DESCRIPTION OF PROPOSED CHANGE AND SAFETY ANALYSIS
PROPOSED CHANGE NO. 97 TO THE TECHNICAL SPECIFICATIONS
PROVISIONAL OPERATING LICENSE DPR-13

This is a request to revise Appendix A Technical Specification 3.7 Auxiliary Electrical Supply.

DESCRIPTION OF PROPOSED CHANGE AND SAFETY ANALYSIS
PROPOSED CHANGE NO. 98 TO THE TECHNICAL SPECIFICATIONS
PROVISIONAL OPERATING LICENSE DPR-13

DESCRIPTION OF PROPOSED CHANGE
AND SAFETY AND ENVIRONMENTAL ANALYSIS
PROPOSED CHANGE NO. 99 TO THE TECHNICAL SPECIFICATIONS
PROVISIONAL OPERATING LICENSE DPR-13

Figure 5.2-1 SOUTHERN CALIFORNIA EDISON COMPANY CORPORATE ORGANIZATION

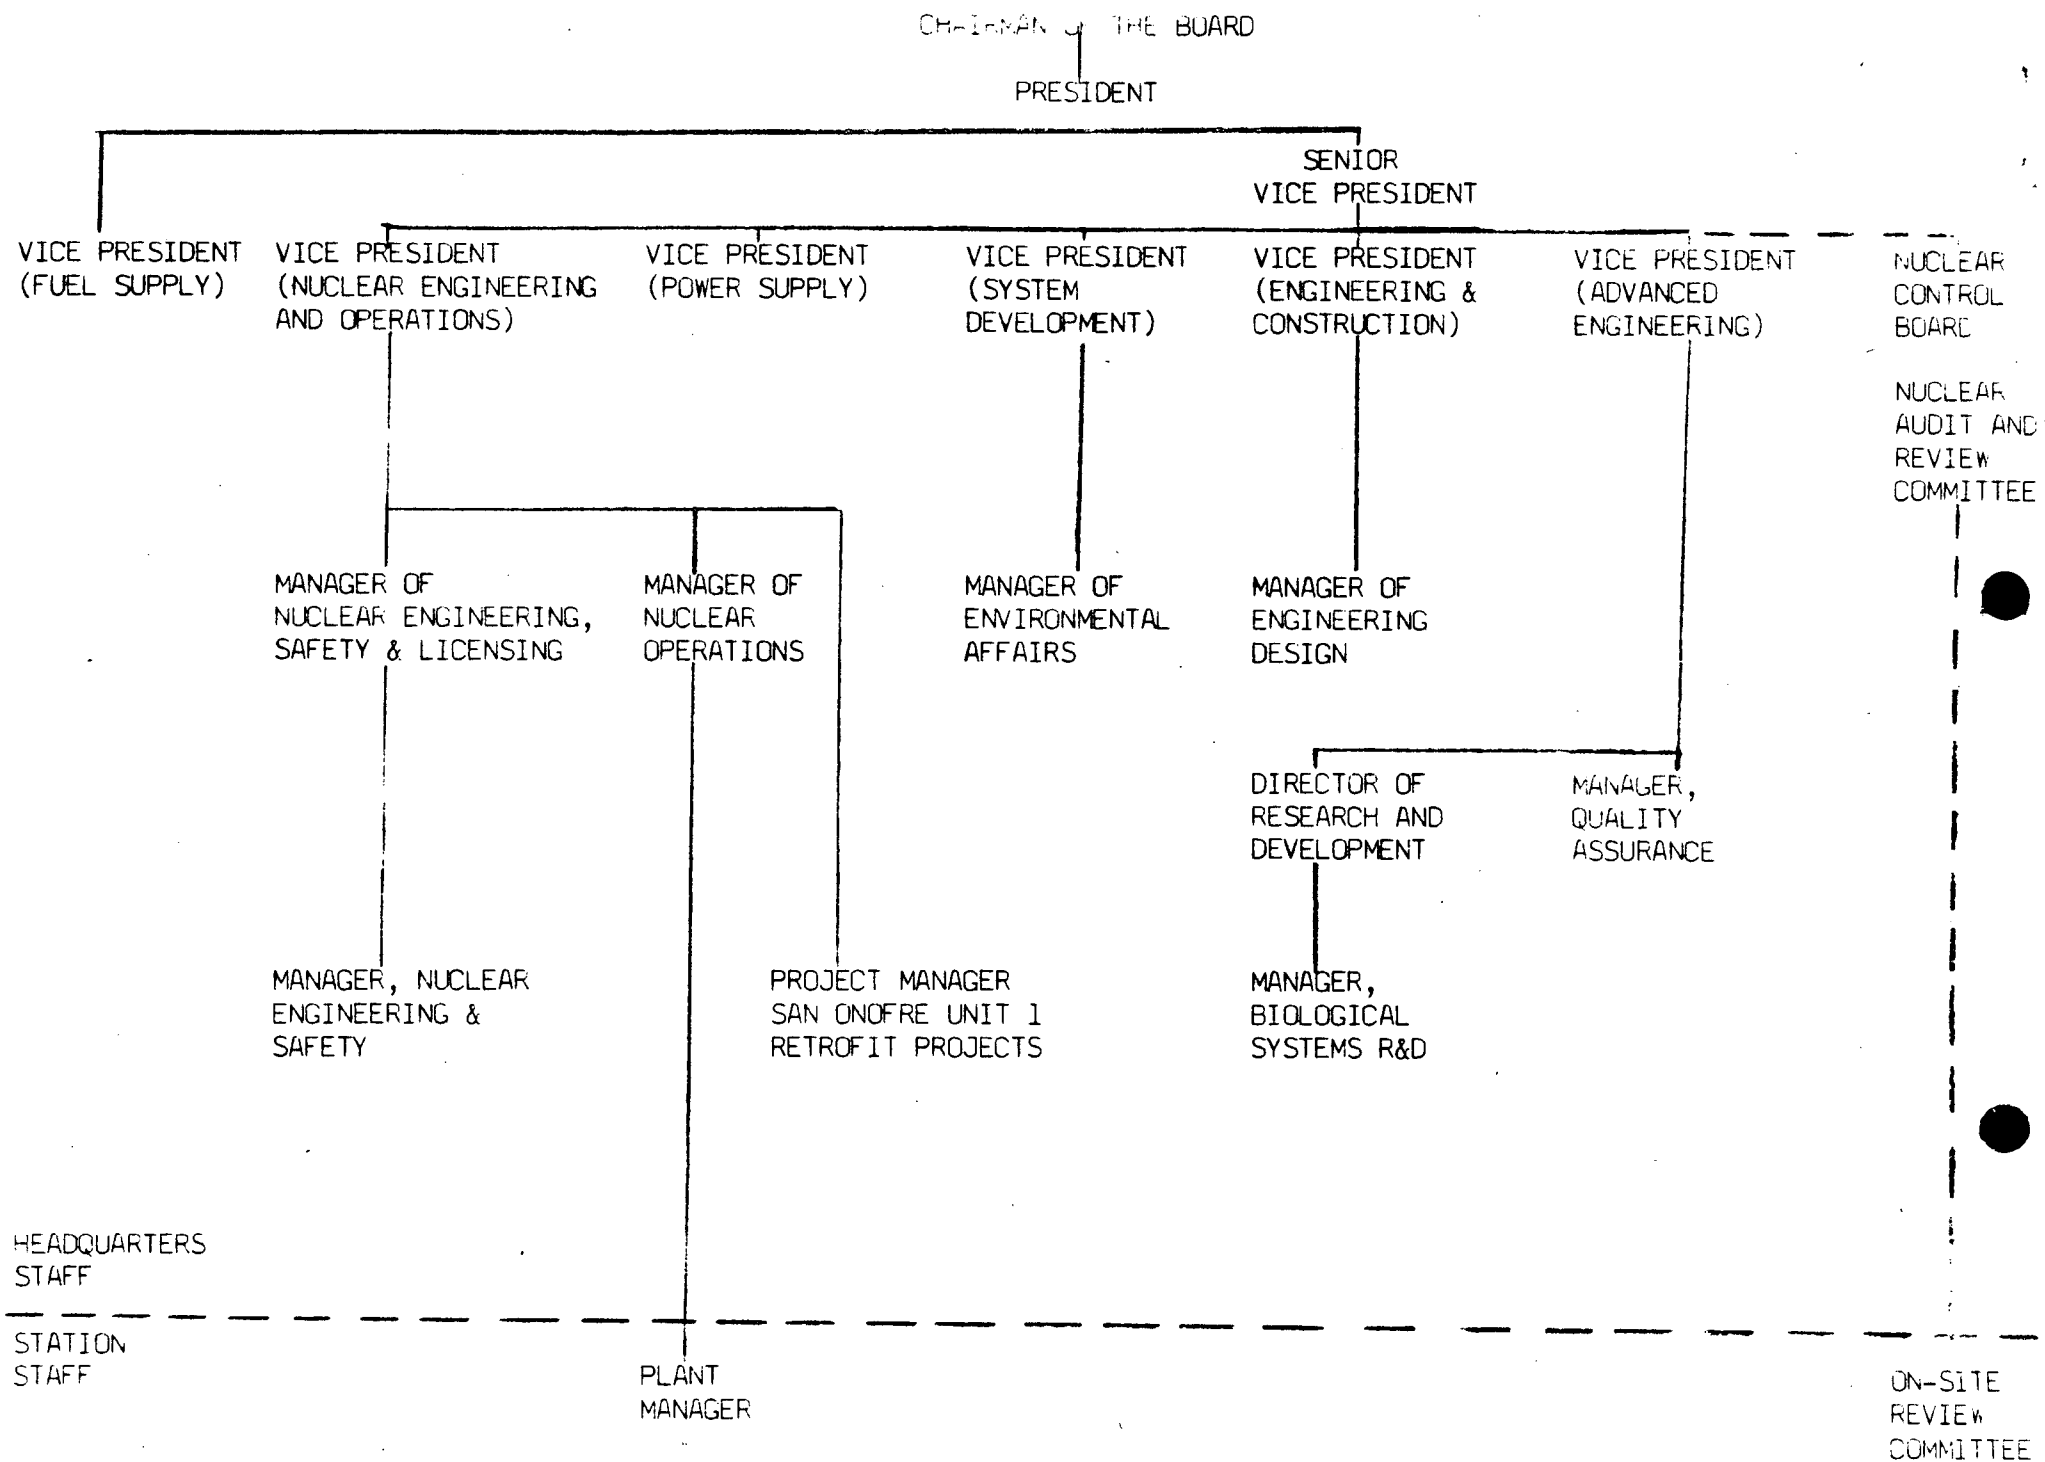
Revised Figure 6.2.1.1, Offsite Organization is attached.

Revised Figure 5.2-1 is attached.
